Letter of Revision #1 Narrative

LETTER OF REVISION 1 FOR  
 CASCADIA - BLOCKS 4-7  
 RIVANNA DISTRICT, ALBEMARLE COUNTY, VA

SHEET TITLE:  
 SITE PLAN AND PROFILES

GUARDRAIL DETAIL  
 SCALE: N.T.S.

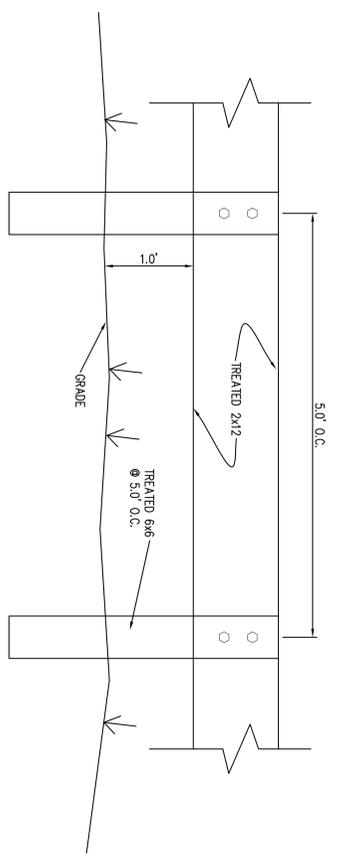
SEE SHEET SP13 OF THE APPROVED CASCADIA BLOCKS 4-7 SITE PLAN TO REFERENCE THE APPROVED SIDEWALK LOCATION

SITE PLAN  
 SCALE: 1"=30'

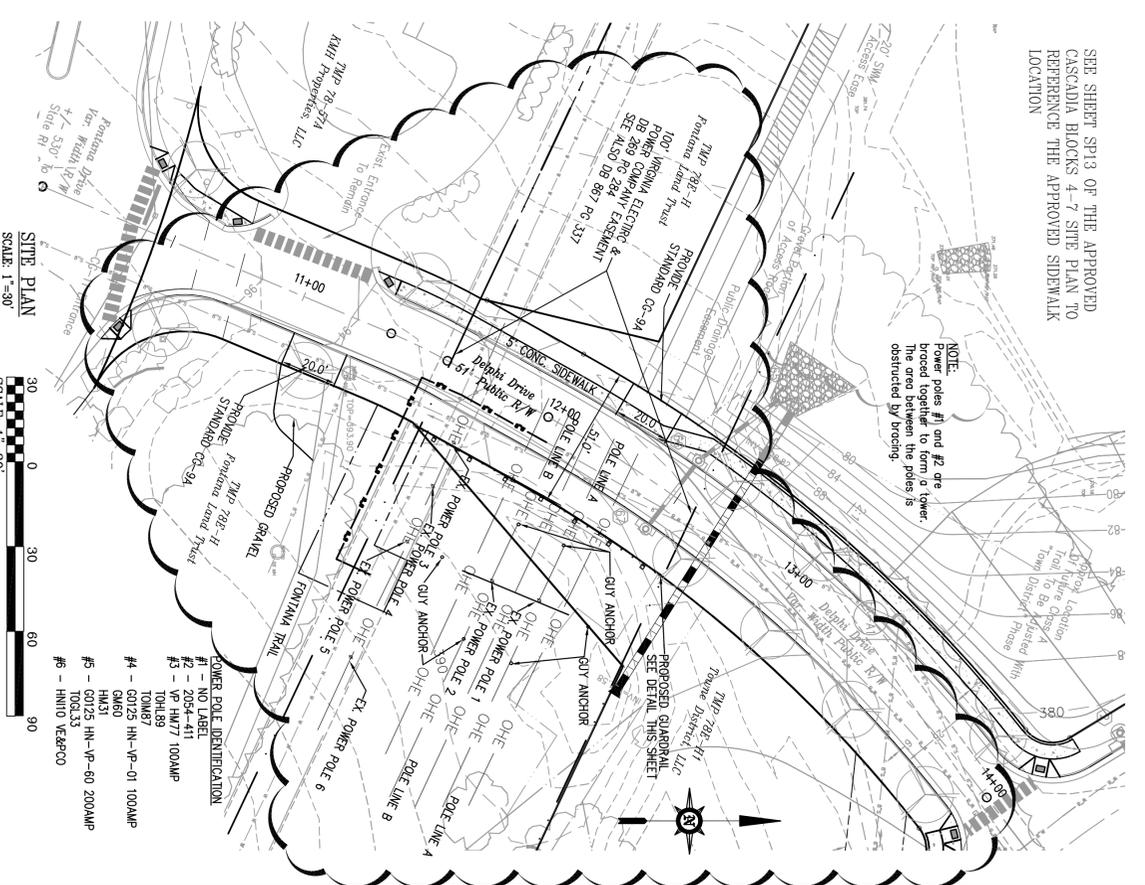
Based on coordination with Dominion Power and Albemarle County, the purpose of this letter of revision is to address Dominion Power concerns relative to the encroachment of Delphi Drive through their 100' right-of-way. The plan proposes that approximately 350 LF of 5' wide concrete sidewalk on the east side of Delphi Drive be removed as shown on the plan. A wooden guardrail is also to be proposed within the 100' Dominion Power easement just off the edge of the VDOT right-of-way for safety purposes. The guardrail is to be maintained by the Homeowner's Association. The purpose of the removal of sidewalk is to minimize potential conflicts with future guy wire/pole relocation.
